## Review 2

# Application P-23-029 Minor Subdivision John and Maryann LLC

229 Avenue B  
Block 55, Lot 25

October 29, 2024

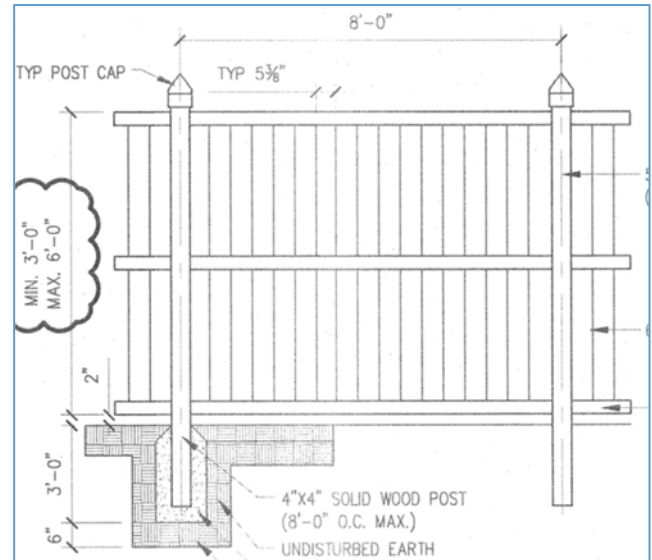
- As indicated in the image to the right, the fence is a board-on-board style PVC fence, colored off-white.
- 4.6. **Plantings.** Per 33-10.11, shade trees shall be provided as part of a residential subdivision at a rate of one tree per lot and located on the street line. Two lots are proposed as part of the subdivision, and two street trees are proposed. The plan complies. The tree species is not proposed at this time. This office recommends that the applicant plant Trident Maples (*Acer buergerianum*). This species is recommended due to the narrow space in which the tree will be planted (effectively only 3.3 feet per tree). We also recommend planting at a size of 2-2½ inches per caliper and granting the applicant a design exception since this smaller size will improve the ability of the tree to survive the transplantation compared to the comparatively large 3½ -4 inch caliper trees required by the applicant. Such a size will require specialized care to survive and grow.

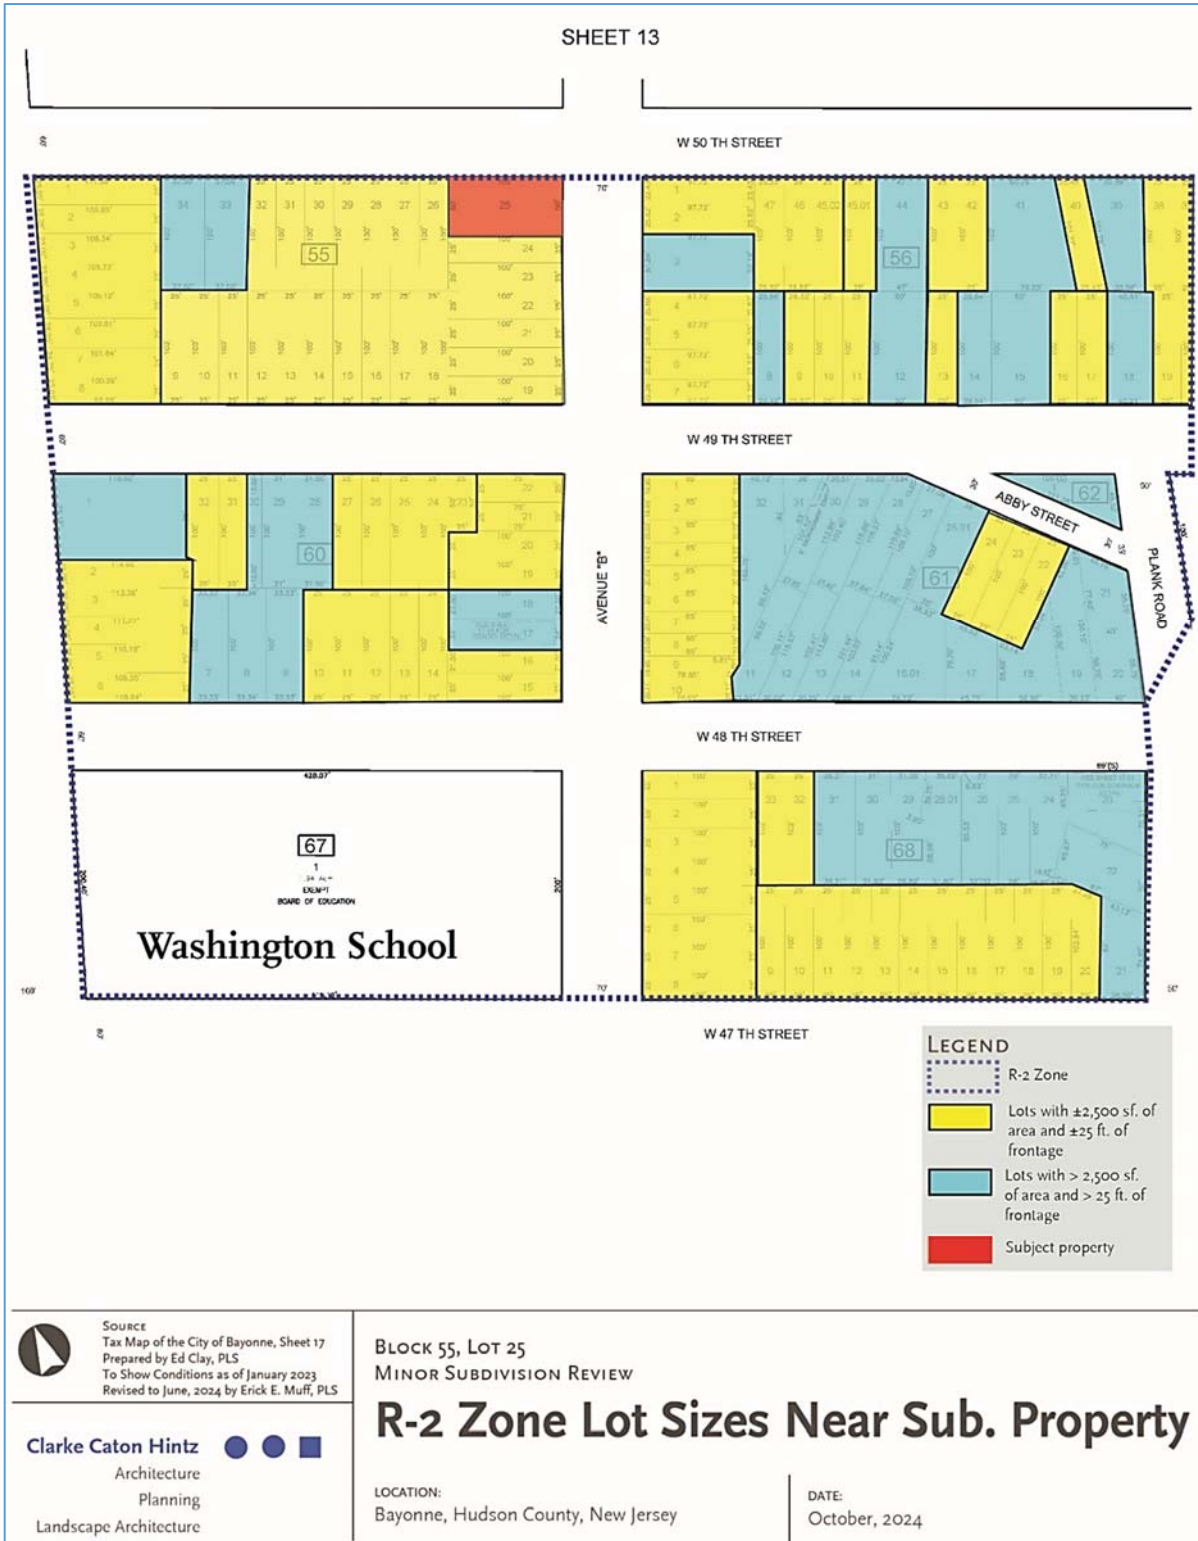
- 5.1. **Lot Size.** Per §35-5.3.e, the proposed lot area for Lots 25.01 and 25.02 is 2,500sf., but the zoning requirement is 3,000 sf. for interior lots (25.01) and 4,000 sf. for corner lots (25.02). The majority of lots in this area of Bayonne, as indicated in the exhibit on the following page, are on lots that are 25' x 100' like the proposed lots.

There is no additional land that the applicant may be able to acquire on either side of the lot to add 5 feet in width to create conforming lots. In addition, §35-16.6 recognizes certain situations where two-family dwellings may be erected on nonconforming lots. This section sets forth these conditions:

The subject lot abuts other residences to the west and south, and the public right-of-way to the north. In theory, adjacent developed lots could be acquired to create a conforming lot size. **The applicant should testify as to whether a good faith effort has been made to purchase a portion any adjoining property.** We note that acquiring all, or a portion of, this land would eliminate an existing residence, or make the lots to be purchased more nonconforming, which would likely result in no net new units to the applicant. The submitted application materials have demonstrated the remaining three criteria for nonconforming lots to be built on without variance relief – if the lots were already in existence. These factors may assist the Planning Board in considering whether or not to grant the variances necessary for this application to be approved.
